Access Compliance Report

Public Rights-of-Way

Intersection ID: 13854	Main Street: E_PARK_AV	Cross Street: SOUTH_BV	Location: SE
ADA ID: CEF4EDDFB881	Ramp Type: PerpDiag	Initial Pass/Fail: Fail	Overall Compliance: No
Severity Score: 8.75			
Codes/Mitigation Info/Possible Solution		Field Measurements/Component Compliance

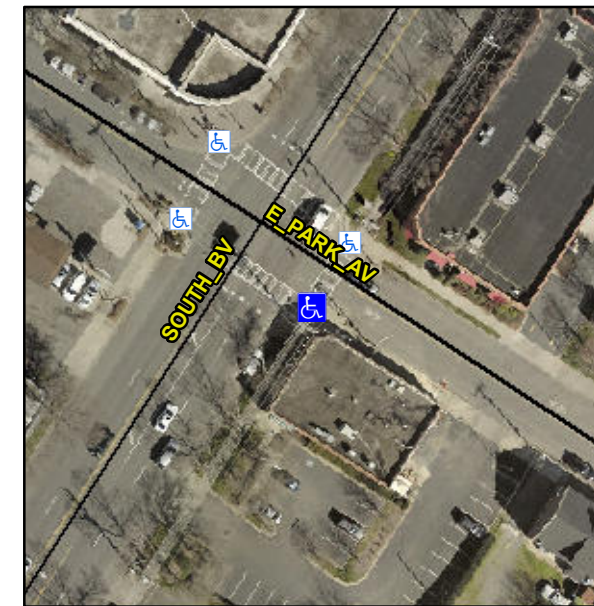
R304.5.1

Compliance	Description	Data	Compliance	Description	Data
N/A	Ramp Length (in)	31.0	Yes	Ramp Slope (%)	7.7
No	Ramp Width (in)	45.0	Yes	Ramp XSlope (%)	1.3
N/A	Flare Type LT	N/A	N/A	Flare Type RT	N/A
N/A	Flare Slope LT (%)	N/A	N/A	Flare Slope RT (%)	N/A
N/A	Flare Traversable LT?	N/A	N/A	Flare Traversable RT?	N/A
N/A	Landing Length (in)	N/A	N/A	DWS Provided?	N/A
N/A	Landing Width (in)	N/A	N/A	DWS Contrast?	N/A
N/A	Landing Slope (%)	N/A	N/A	DWS Length (in)	N/A
N/A	Landing X Slope (%)	N/A	N/A	DWS Full Width?	N/A
N/A	Landing Curb? (Y/N)	N/A	N/A	DWS Offset (in)	N/A
N/A	Shared Landing?	N/A			
N/A	Gutter Ponding?	N/A	N/A	Gutter Slope (%)	N/A
N/A	Gutter Lip Ht (in)	N/A	N/A	Gutter X Slope (%)	N/A
N/A	Painted X Walk1?	Yes	N/A	Painted X Walk2?	Yes
	X Walk 1 Direction	To NE		X Walk 2 Direction	To NW
N/A	X Walk 1 Width (in)	108.0	N/A	X Walk 2 Width (in)	107.0
	X Walk 1 Slope (%)	0.5		X Walk 2 Slope (%)	0.1
	X Walk 1 X Slope (%)	0.4		X Walk 2 X Slope (%)	0.5

Remove & Replace Curb Ramp With Two New Directional Ramps or Equivalent. Restripe Crosswalk.
